Product Change Notification / LIAL-31LFQR391

CCB 4255 Initial Notice: Qualification of GTK as a new assembly site for selected Atmel AT27C0xx device families available in 32L PDIP (.600in) package.

CCB 4255
Pre and Post Change Summary
PCN# LIAL-31LFQR391

Tube Drawing

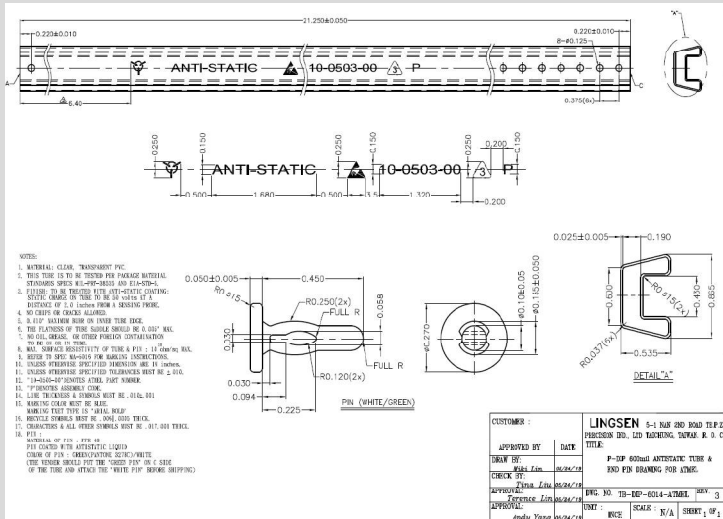
PRE-CHANGE (LPI)						POST-CHANGE (GTK)

Package	Lead Count	Body Size	Units/Tube	Length (inch)	End Plugs	Package	Lead Count	Body Size	Units/Tube	Length (inch)	End Plugs
PDIP	32	600 mils	12	21.250+/- 0.050	White/Green	PDIP	32	600 mils	12	23.47+/- 0.030	White/Blue
